ADDENDUM NO. 2

October 27, 2022

Carey Ridge Elementary Addition & Renovation
16231 Carey Road
Westfield, IN 46074

DRAWING NUMBER
A409

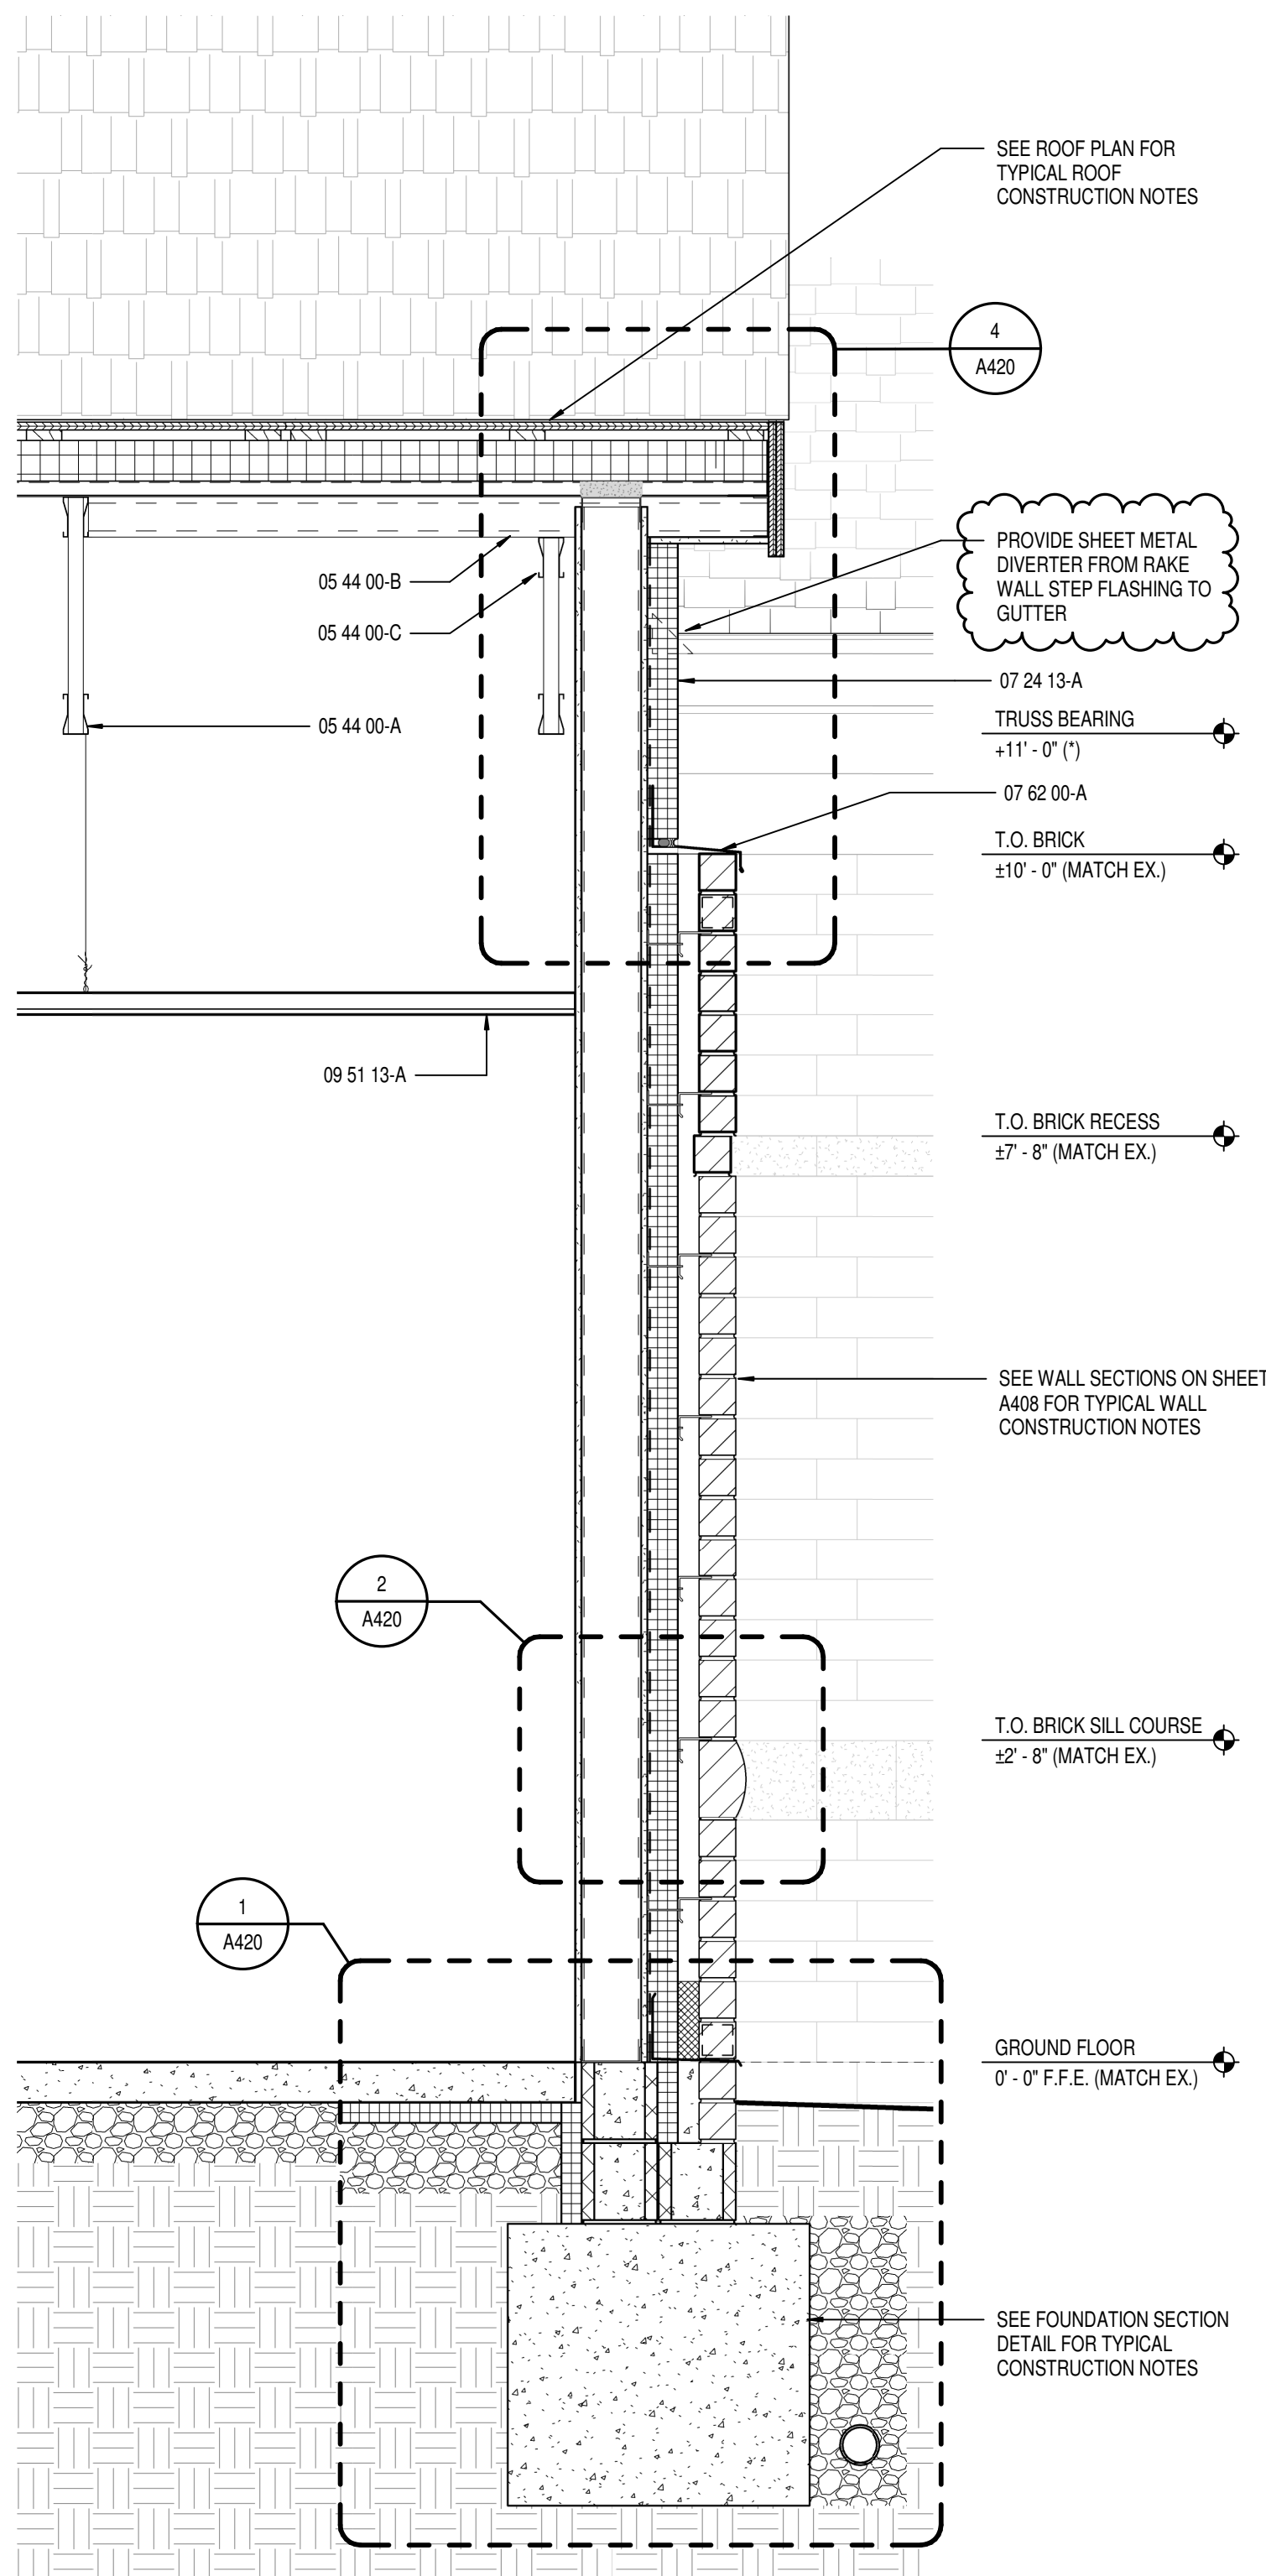
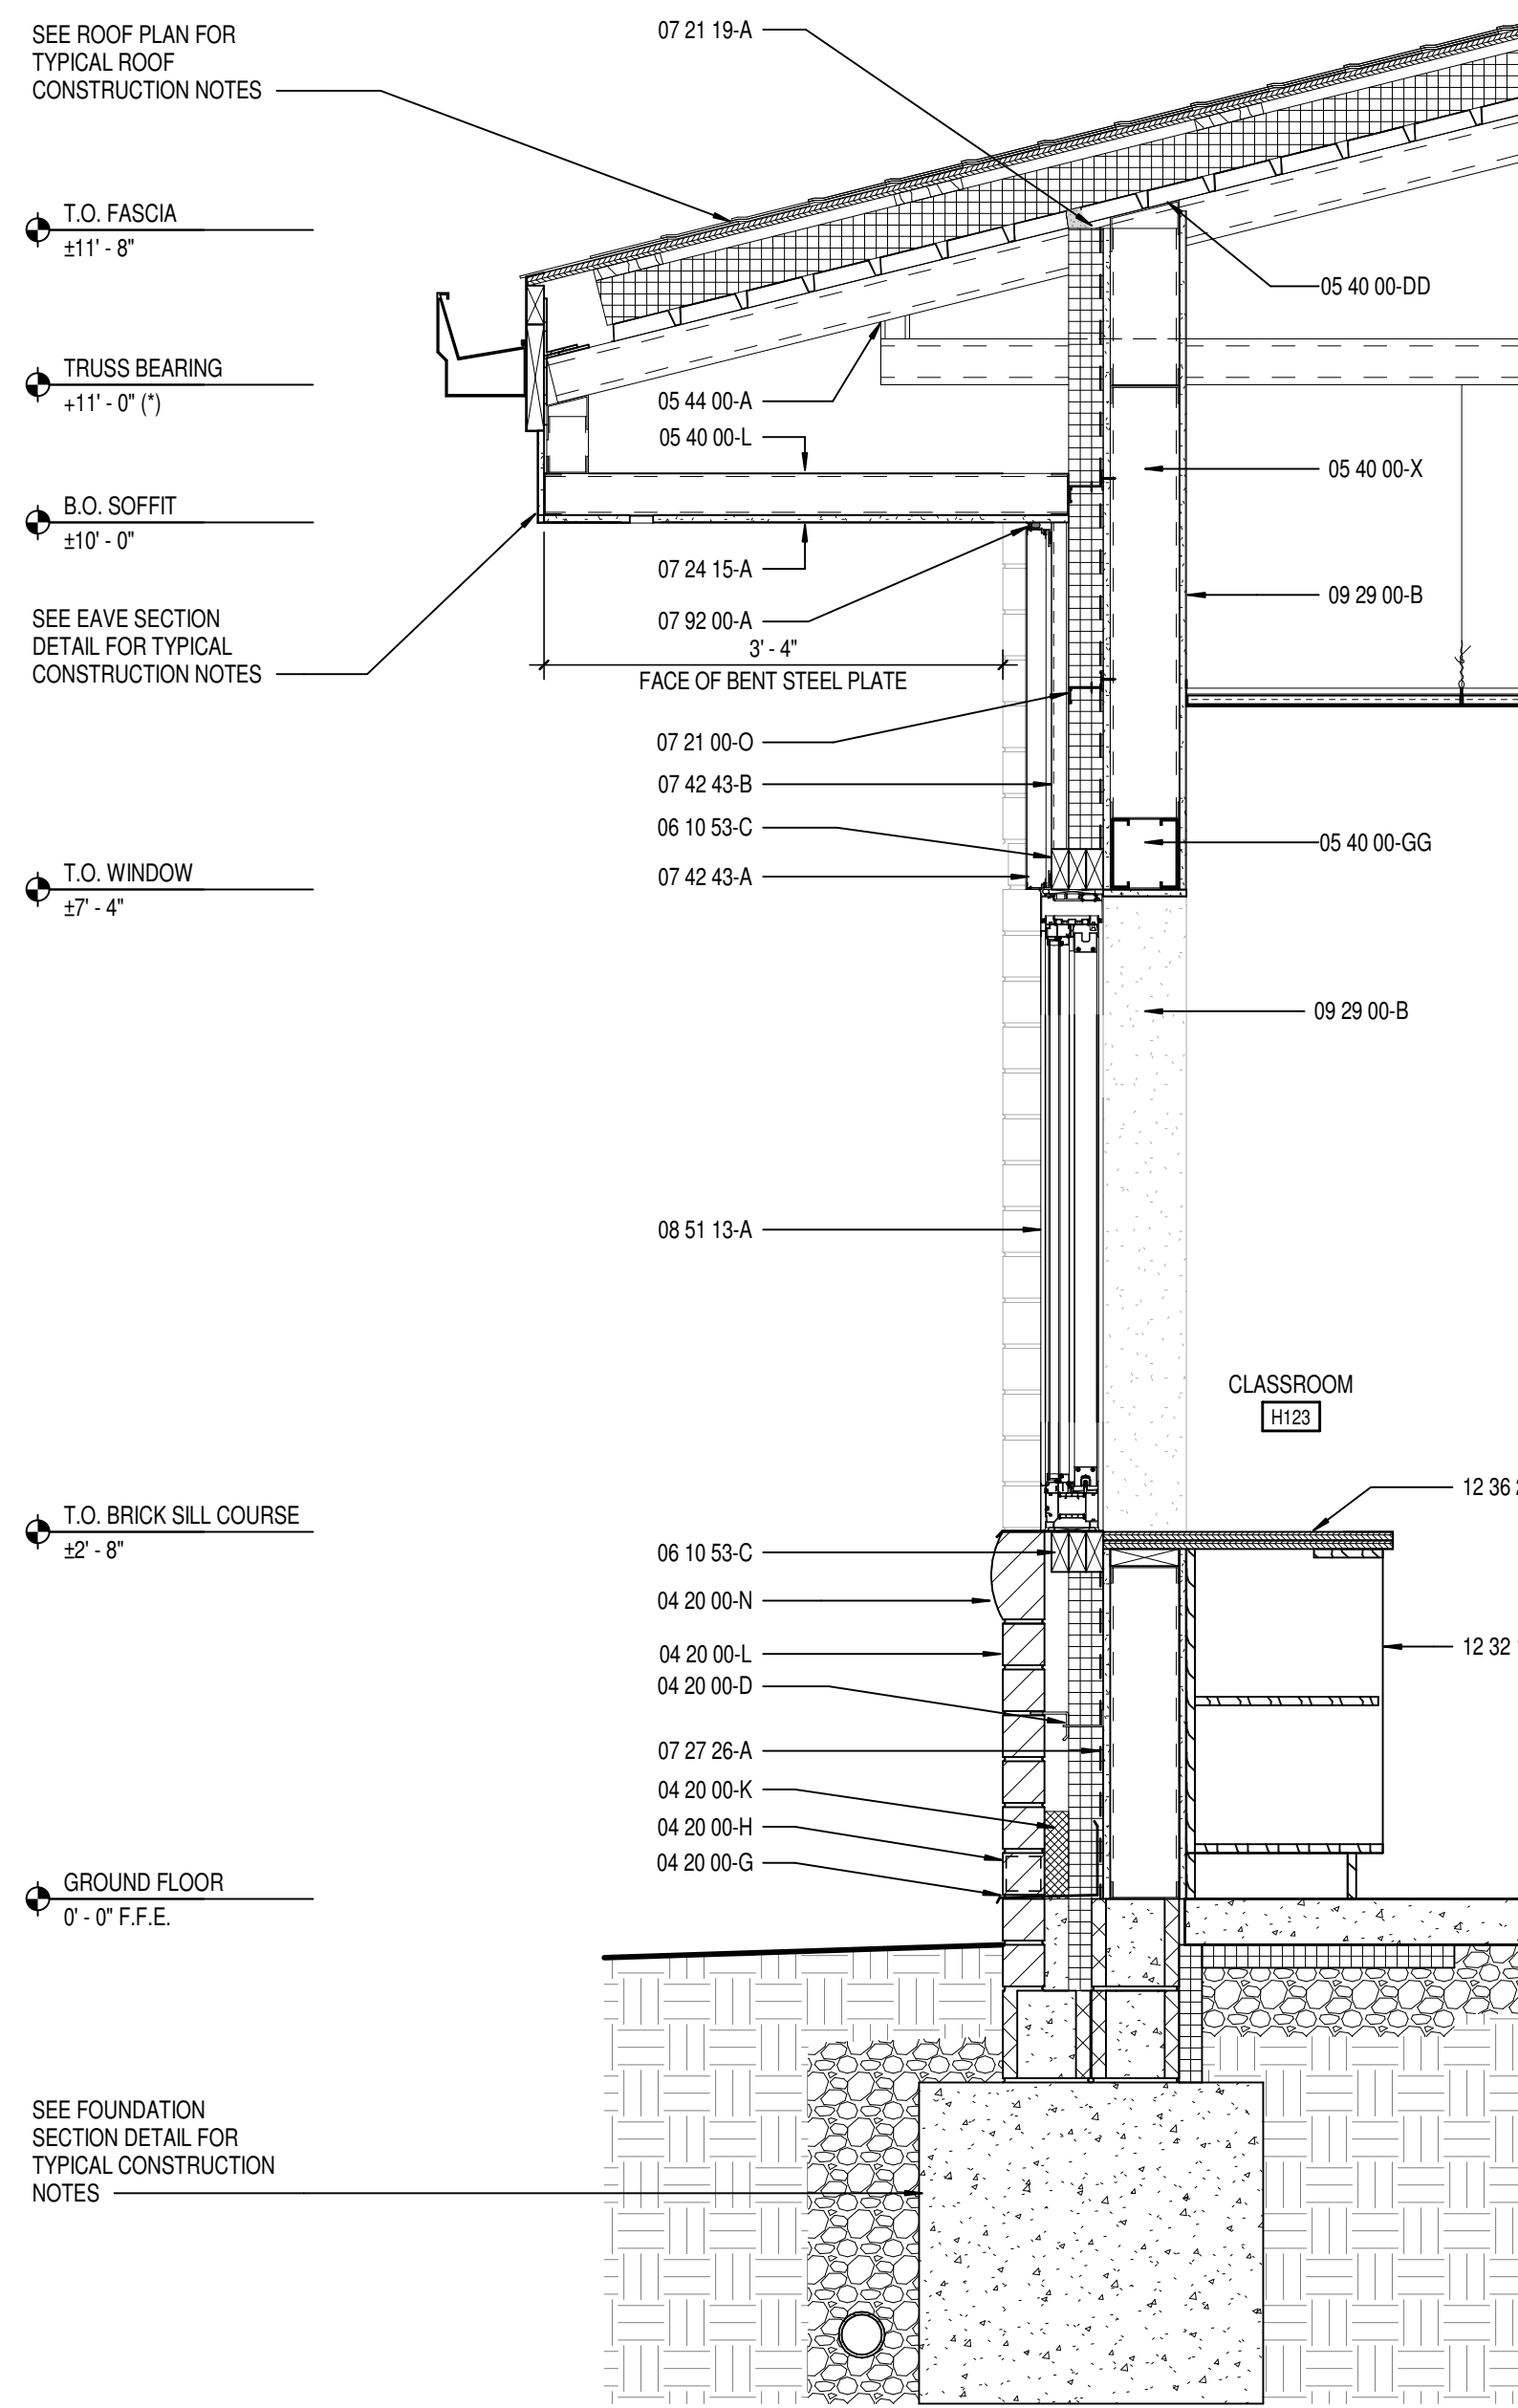
- A. Wall Section 3/A409
1. Removed rake overhang dimension, refer to Section Detail 4/A420 for dimension.
 2. Added note to provide sheet metal water diverter at bottom of lower rake wall roof slope to divert water into gutter.
